Docket Number:	85-AFC-01C
Project Title:	Compliance - Watson Cogeneration Company AFC
TN #:	264560
Document Title:	PETITION TO AMEND - Modification of the CEC's Jurisdictional Site Boundaries to Exclude Areas of Previous Construction Work
Description:	PETITION TO AMEND - Modification of the CEC's Jurisdictional Site Boundaries to Exclude Areas of Previous Construction Work.
Filer:	Anwar Ali
Organization:	California Energy Commission
Submitter Role:	Commission Staff
Submission Date:	7/3/2025 10:53:41 AM
Docketed Date:	7/3/2025

Subject: Watson Cogeneration Project (85-AFC-01C): Petition to Amend

**WATSON COGENERATION PROJECT
(85-AFC-01C)
PETITION TO AMEND**

Figure 1: New Sub 1F 220 kV GIS

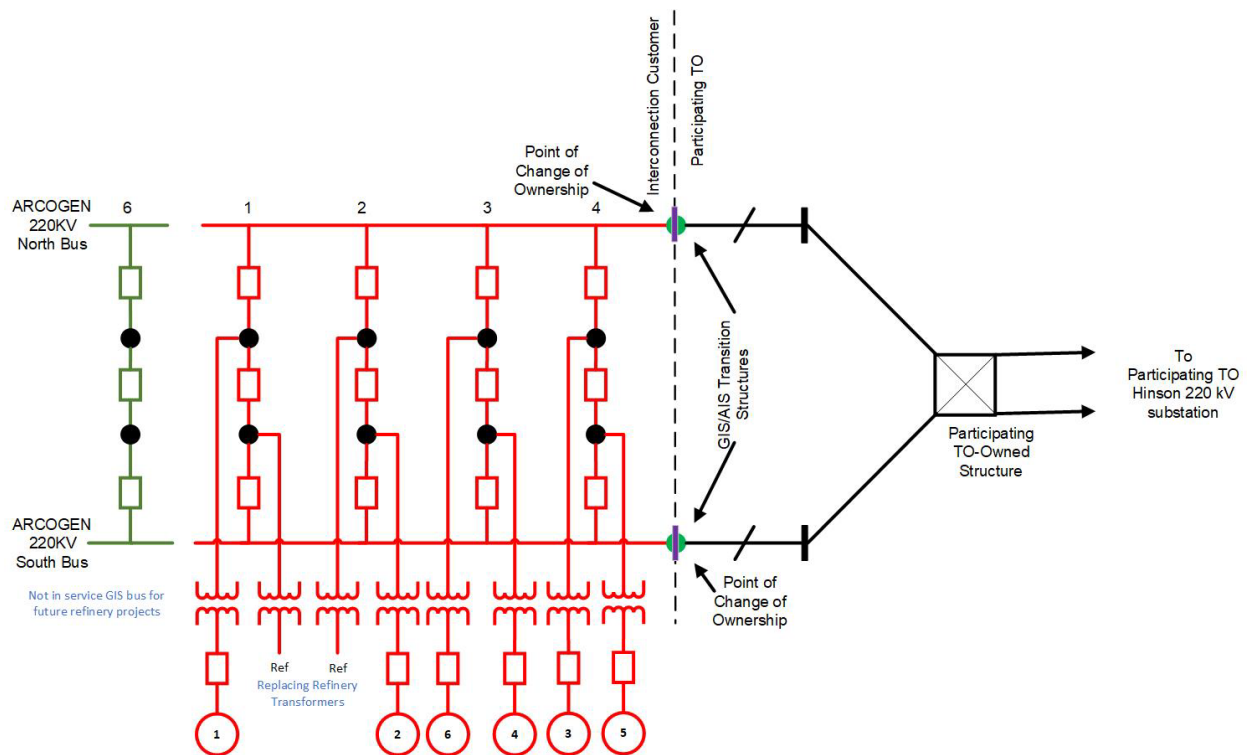
(1) Addition of three new 220 kV GIS within the existing Sub 1F substation at the Watson Cogen.

The new GIS are located in the existing Sub 1F substation and laid out in a breaker and a half arrangement. The GIS is the same breaker and a half arrangement that is currently used in the Watson Cogen's design, which will continue to ensure very high reliability and limit short circuit current to the existing electrical equipment to prevent equipment damage and ensure personnel safety. While the GIS were originally planned to connect to the two (2) new 150 MVA 220/69 kV transformers that feed the Refinery complex's 69 kV GIS substation, currently the Project Owner does not intend to commission the three new 220 kV GIS breakers or otherwise interconnect the new 220 kV GIS. The Project Owner seeks to keep open the possibility of the new 220 kV GIS to be commissioned in the future, at which time the Project Owner will confer with CEC Staff regarding consistency with the CEC certification. The work is being conducted to

The location of the new 220 kV GIS is within the existing Watson Cogen substation and does not require physical modification of the substation building. Additionally, the construction and installation of the new GIS has been reviewed and approved by the City of Carson, which performed plan check and other chief building official duties.

This proposed change does not require any new language for any conditions of certification and does not affect the design or operation of the Watson Cogen. The new Sub 1F 220 kV GIS are depicted in Figure 1 in spot 6, between the ARCOGEN North and South 220kV bus.
